**To:** Samantha Crowder (Land Perspectives LLC)  
**From:** Christopher LaRue, Senior Planner  
**Date:** March 20, 2020  
**Re:** PP-001137-2020: Collier Hill 4G Preliminary Plat Application  
**cc:** Deborah Bachelder, Joe Smith, David Pasic, Darren Champion

### **Colliers Hill Filing 4G Preliminary Construction Plans**

COLLIERS HILL FIL 4G - PP-001137-2020  
 PRELIMINARY CONSTRUCTION PLANS  
 FLORA VIEW DRIVE  
 SIGNING & STRIPING PLAN  
 Prepared for: DAYBREAK RECOVERY ACQUISITION, LLC

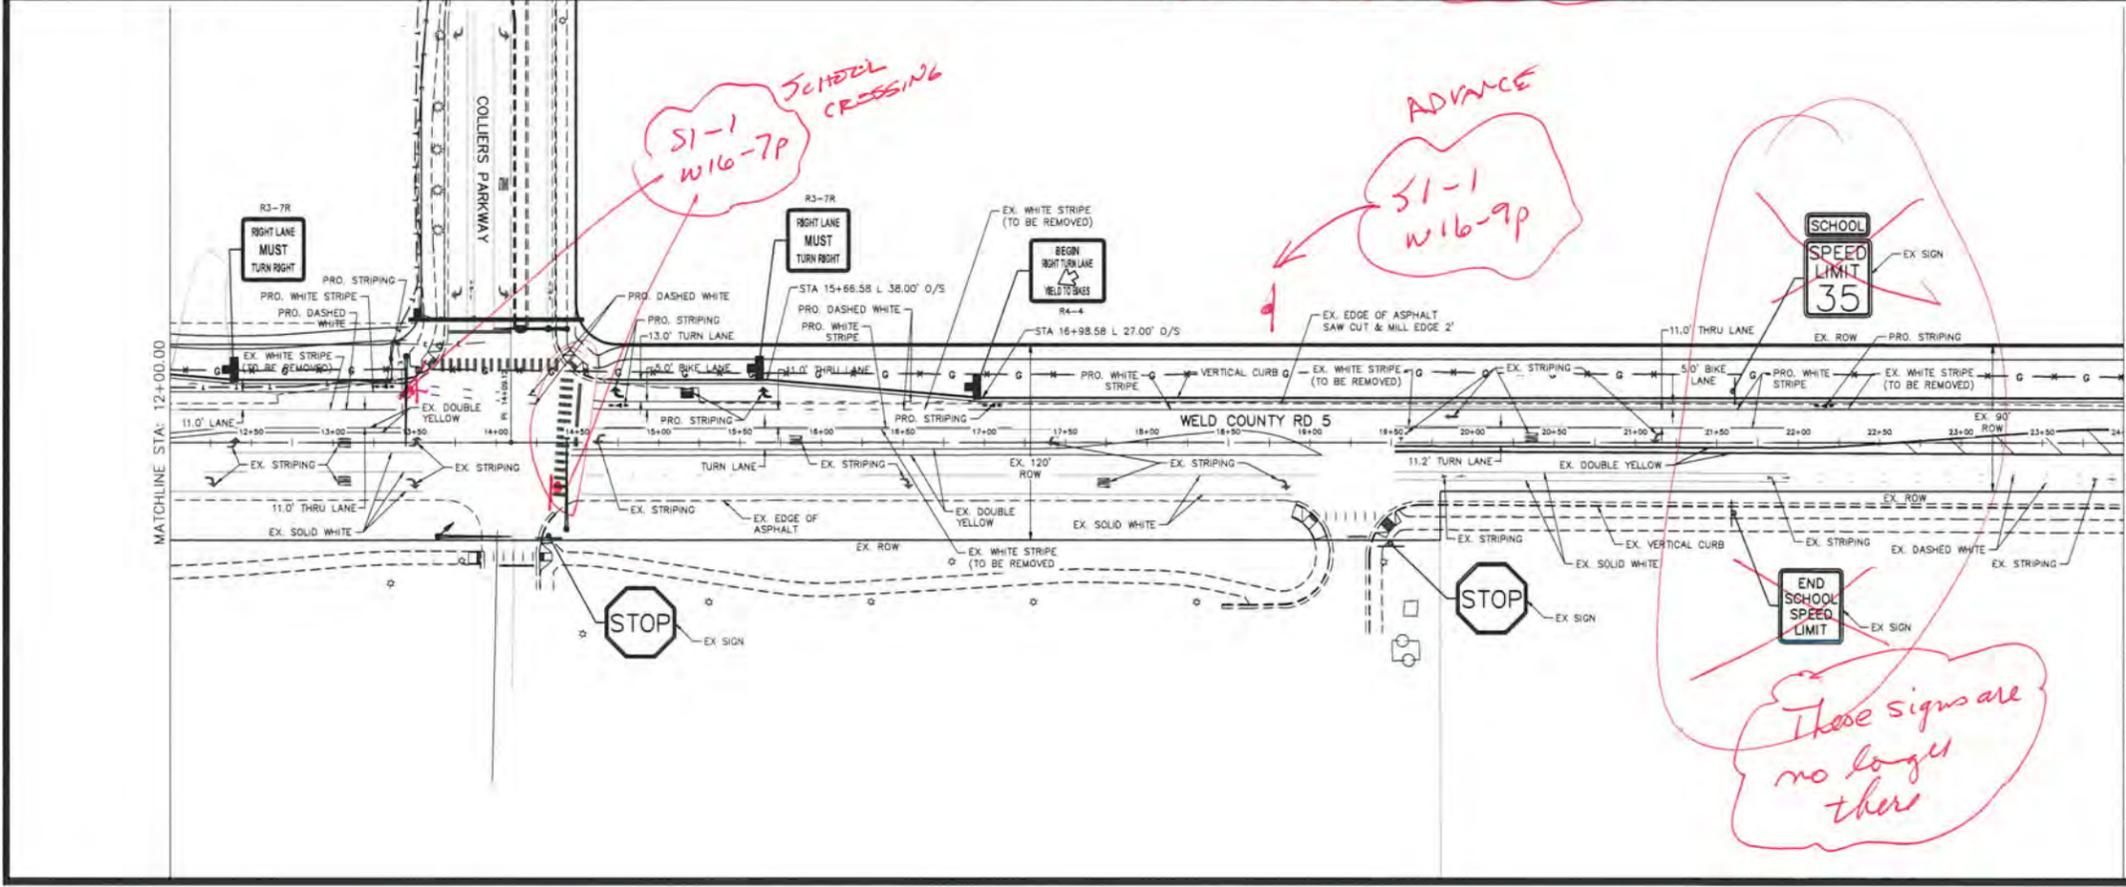
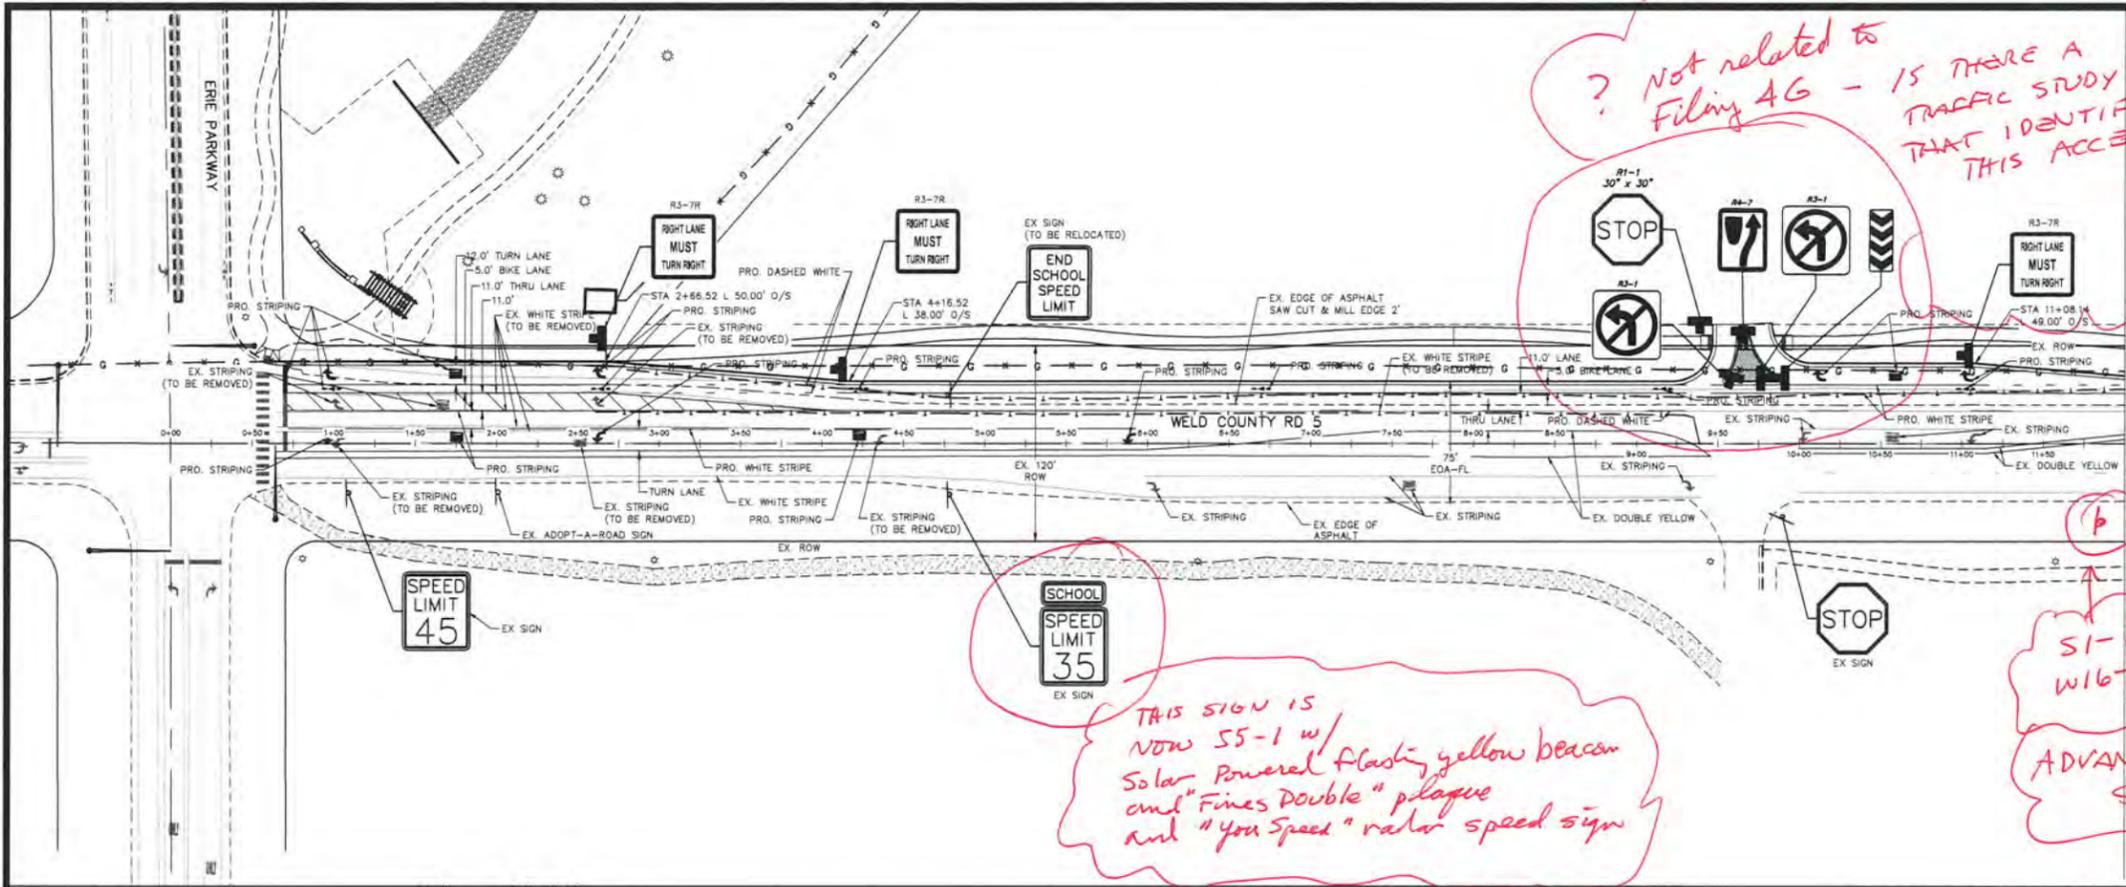
? Not related to Filing 4G - IS THERE A TRAFFIC STUDY THAT IDENTIFIES THIS ACCESS?

THIS SIGN IS NOW 55-1 w/ Solar Powered flashing yellow beacon and "Fines Double" plaque and "You Speed" radar speed sign

WELD COUNTY ROAD 5  
PRELIMINARY CONSTRUCTION PLANS  
SIGNING & STRIPING PLAN  
2 OF 2  
Prepared for: CLIENT

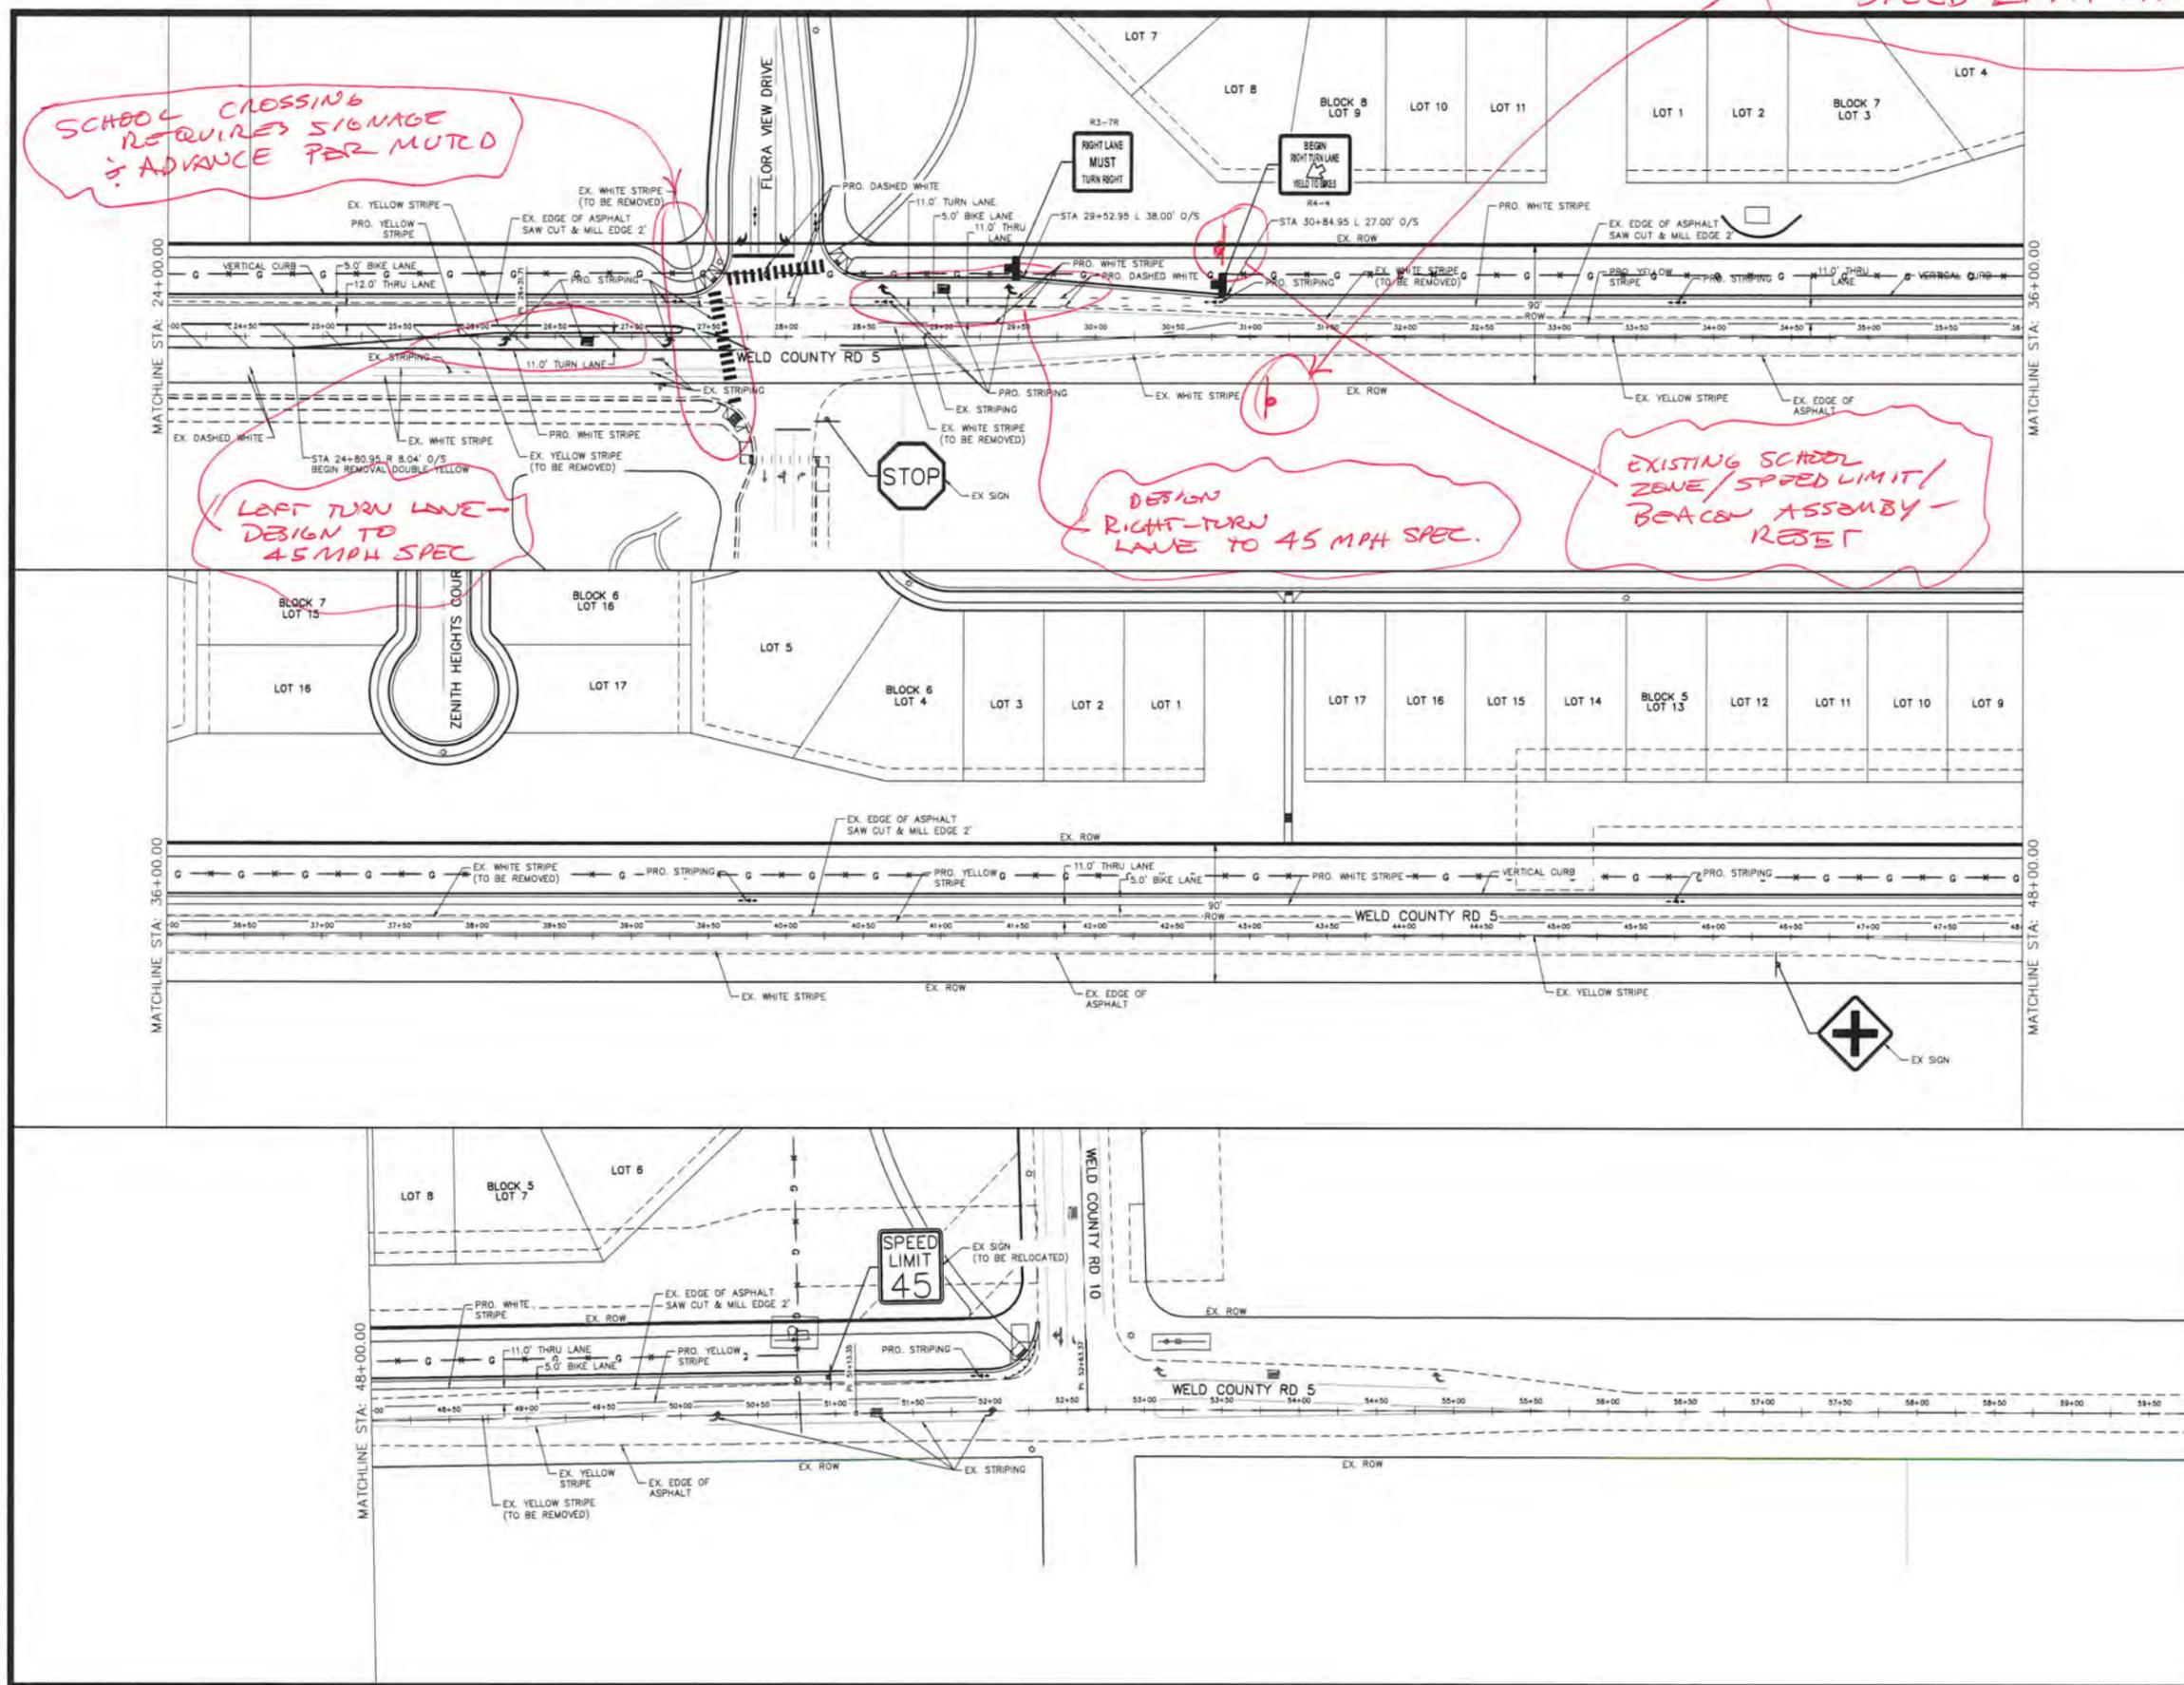
8. Sheet 8 does not show the existing School Zone Speed Limit/Fines Double/Flashing Yellow Beacon/Your Speed radar sign assembly southbound approaching the Soaring Heights access. This sign assembly may need to be reset with improvements to WCR 5. An existing "End School Zone" sign is not shown opposite this assembly. This sign may also need to be reset, or replaced with a "Speed Limit 45" sign.
9. The left-turn and right-turn lanes at Flora View Drive do not meet standards for the 45 MPH speed limit. Auxiliary lanes should provide 275 feet full-width deceleration and 160 feet of taper (435 feet total).

LEFT TURN LANE - DESIGN TO 45 MPH SPEC

DESIGN RIGHT-TURN LANE TO 45 MPH SPEC.

EXISTING SCHOOL ZONE / SPEED LIMIT / BEACON ASSEMBLY - RESET

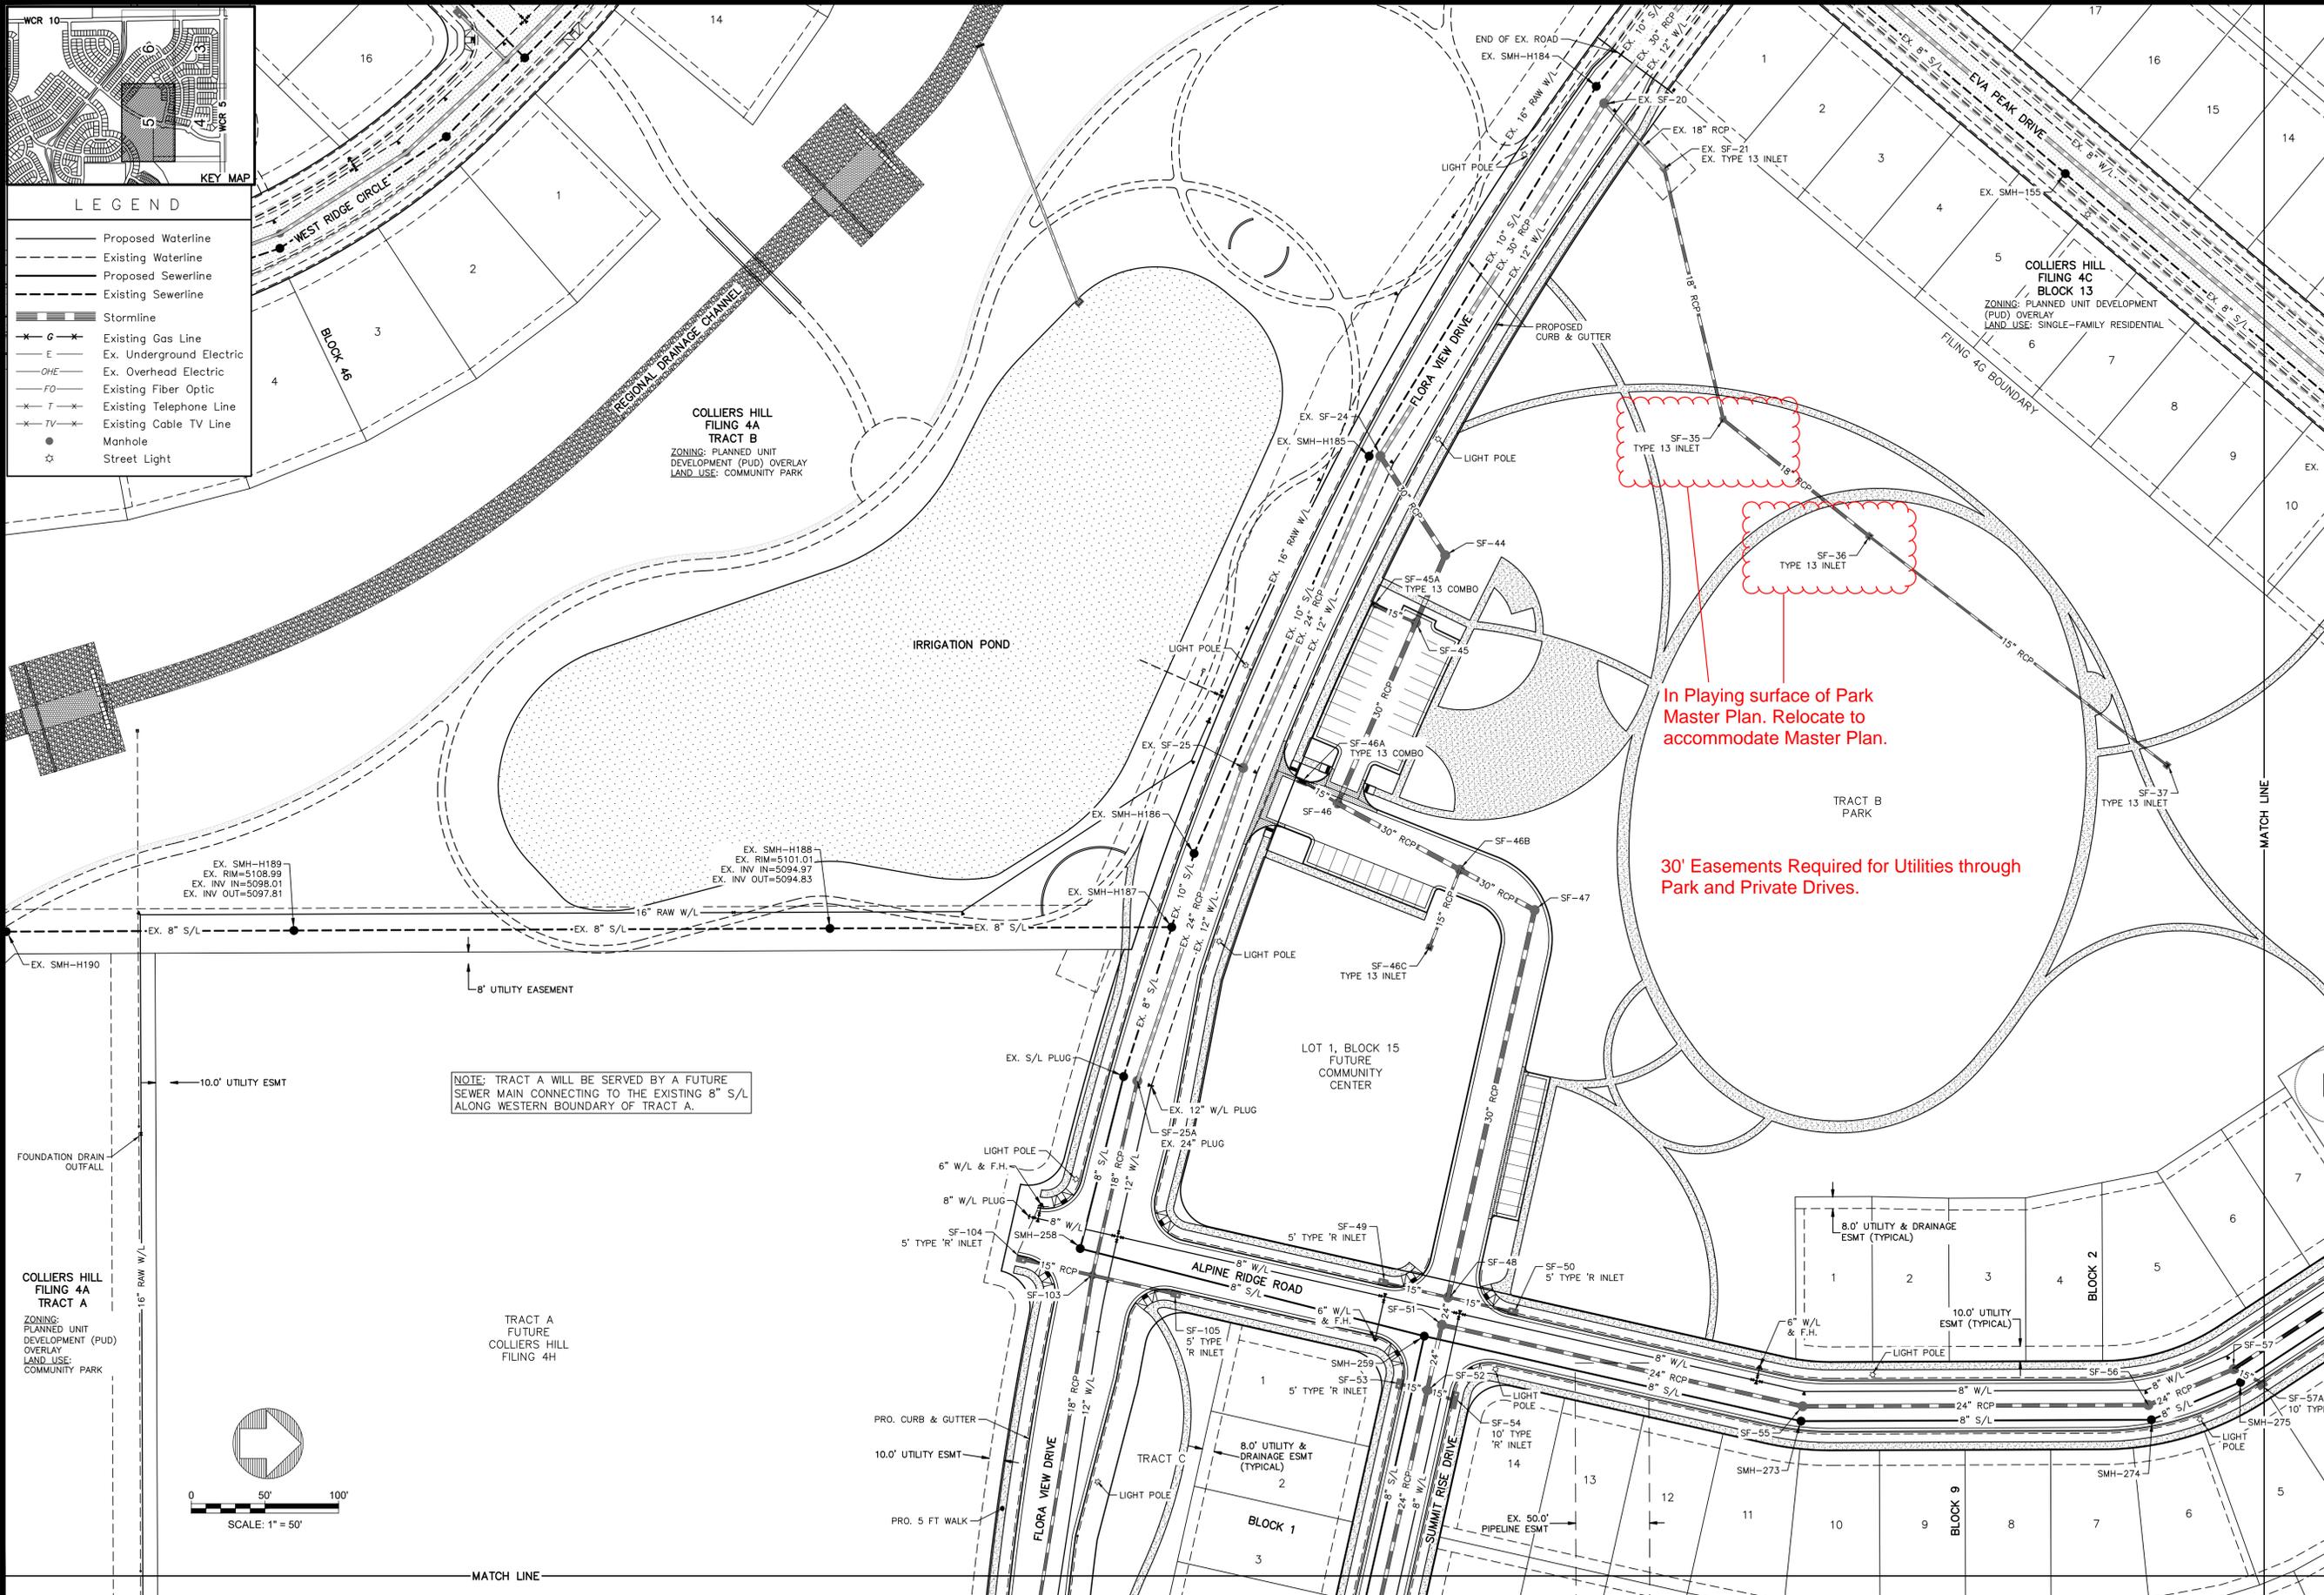
In Playing surface of Park Master Plan. Relocate to accommodate Master Plan.
